Date: 23rd October 2025
JSA Job Ref.: 24126

RE: DEMOLITION OF BUILDINGS/STRUCTURES AND CONSTRUCTION OF A 14 STOREY BUILDING INCLUDING OFFICE USE, ARTS CENTRE AND CAFÉ, AUDITORIUM, AND ANCILLARY USES AT SITE BOUND BY CITY QUAY TO THE NORTH, MOSS STREET TO THE WEST & GLOUCESTER STREET SOUTH TO THE SOUTH, DUBLIN 2. THE SITE INCLUDES 1-4 CITY QUAY (D02 PC03), 5 CITY QUAY AND 23-25 MOSS STREET (D02 F854).

ACP CASE NUMBER: ACP-323120-25

Appeal Response on Sunlight and Daylight Matters
Applicant: Ventaway Ltd.

Figure 2.1: Renderings generated for 3DDB's APS H/WPSH impact assessment of window '2c' of 7 to 8 City Quay - Baseline (R), Proposed (L) Sun positions are indicated for summer (yellow) and winter (blue); Georges Quay House (red) was not included in Solearth's analytical model

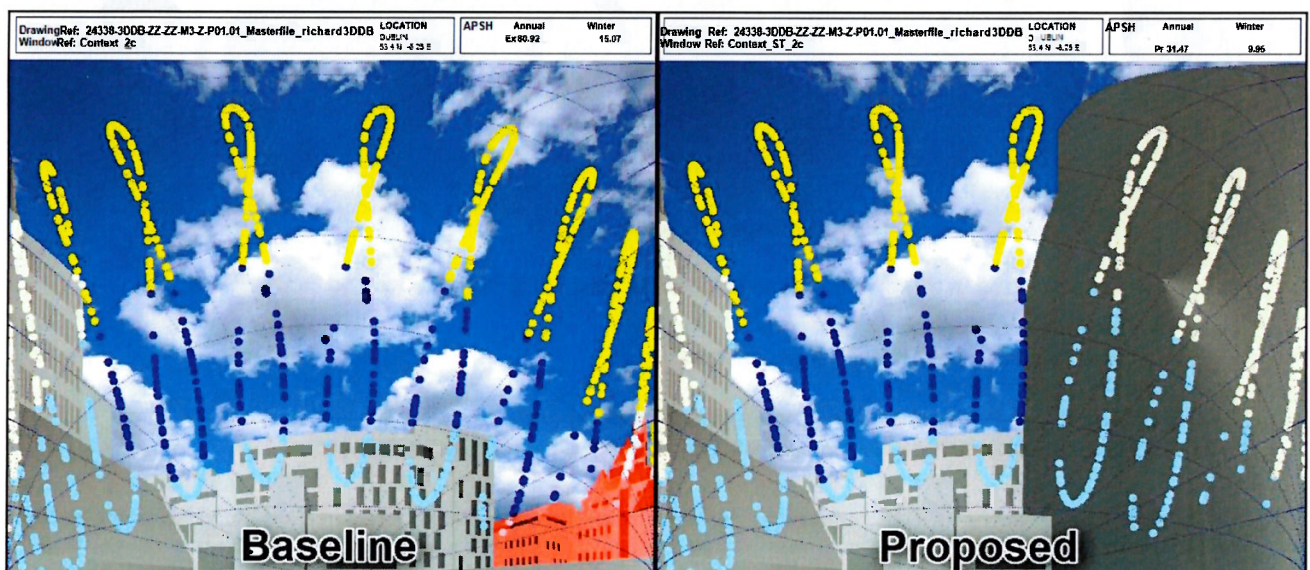
The concern raised by 3DDB in the original response document was that the appellant did not include the existing building, Georges Quay House, in their model state representing the existing state. The fact that the proposed development is situated between the assessed windows on 7/8 City Quay and the omitted, existing building 'Georges Quay House is of particular importance in the context of this study.

As demonstrated in Figure 2.1 below, Georges Quay House is visible from the assessed windows of 7/8 City Quay in the baseline state, but is not visible in the proposed state.

By omitting Georges Quay House from their baseline model, Solearth's study incorrectly calculates unobstructed skylight access. This artificially inflates the baseline figure, which in turn exaggerates the perceived impact of the proposed development. The assessment is therefore not a like-for-like comparison and its findings are unreliable.

Figure 2.2: 'Existing Situation' March 21st, 3pm as represented in the Solearth report (R), Areas indicating flawed model in the same image (L).

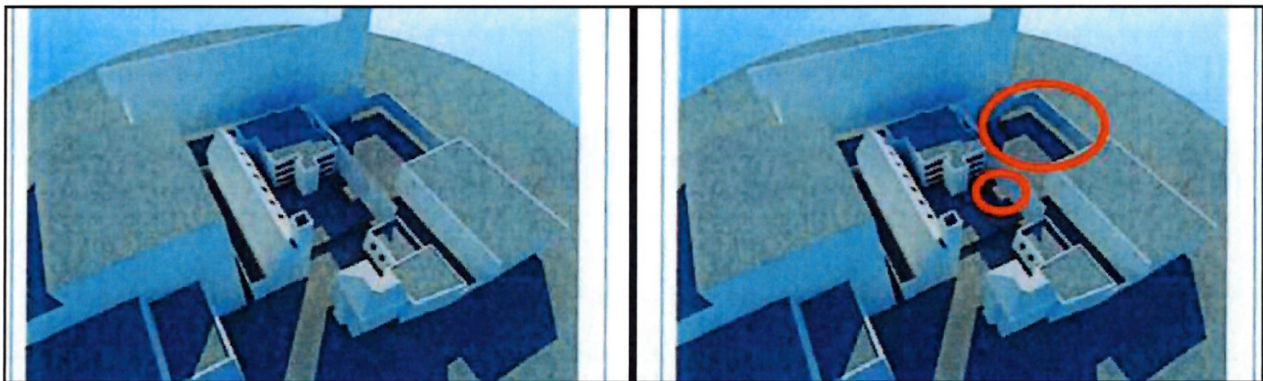
- *"The applicant has pointed out that in the shadow diagram there is a discrepancy in 2 of 14 image set between the before and after shadow directions which should be the same. They suggest that because of this the model is flawed and comparison impossible. We accept that two images were incorrectly inserted in the table. A balanced review of all other image set however shows that the models are consistent. This error is one of presentation not of assessment and does not call into question in any substantive way the finding of this part of the report. These images have been corrected and are included in the updated table in the Appendix below."*

However, this presentation error was not the primary flaw identified by 3DDB. The primary issue, which remains unaddressed in their updated submission, is that the ground plane receiving the shadows appears to have been modelled at an incorrect level. As highlighted in our previous response document and shown again in Figure 2.2 below, this fundamental error has not been rectified and undermines the validity of the entire shadow analysis.

We welcome the correction applied to the shadow study images which has been updated to show consistent before and after renderings. The viewer can now make an informed comparison between the before and after renderings on May 21st. We note that of the two updated images, the proposed development results in overshadowing into the school yard at 2pm only, with no additional shadows cast in this area at 12 noon on this date.

Figure 2.3: Renderings showing the annual sun-path as calculated in the baseline state from window '2c' of '7 to 8 City Quay'. Sun positions are indicated in yellow for summer and in blue for winter.

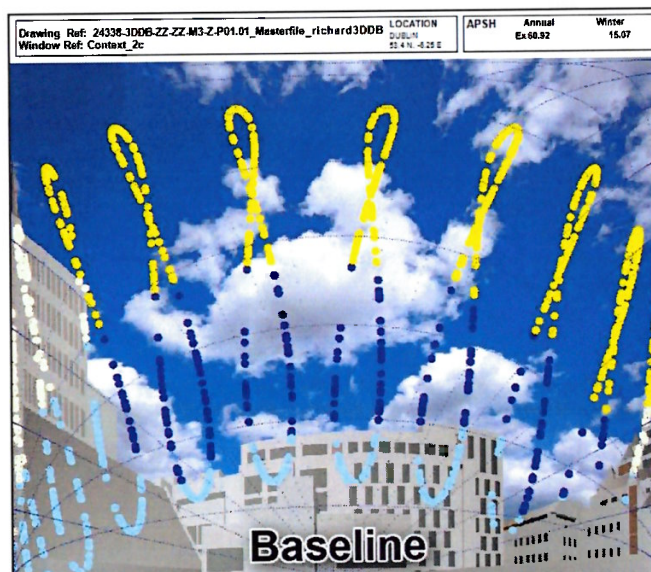
"3DDB suggest that because a building some 50m away from the receptor was not included in our model that our before (baseline condition in their terminology) is reading as lower (presumably intended to read higher ie better) than is accurate which in turn means the after level appears much worse."

The appellant has misrepresented our previous statement. We did not state that the baseline condition was lower 'because' City Quay House was not included in the assessment model. We highlighted that their baseline results were inexplicably low 'in spite of this omission, which should have artificially inflated them.

While minor differences between two models are expected, the disparity here is significant. In some cases, Solearth's calculated sunlight values are less than half of those produced by 3DDB. This discrepancy cannot be attributed to routine modelling or calculation differences. This poses the question of which of the two studies has been correctly implemented.

The assessed windows of 7 to 8 City Quay have a strong southerly orientation, and are not highly constrained in the baseline state. As indicated in Figure 2.3, which also formed part of the previous response, the results generated by 3DDB are consistent with the expectation of the level of sunlight when orientation and obstructions are considered.

By contrast, Solearth's assessment of the same windows show a much lower level. In some cases the APSH/WPSH results in the Solearth report are less than half of that calculated by 3DDB. This does not align with a reasonable expectation for sunlight access for these windows given that they have a favourable orientation and are not overly constrained. It was on this basis, that 3DDB questioned the validity of Solearth's findings in this regard.
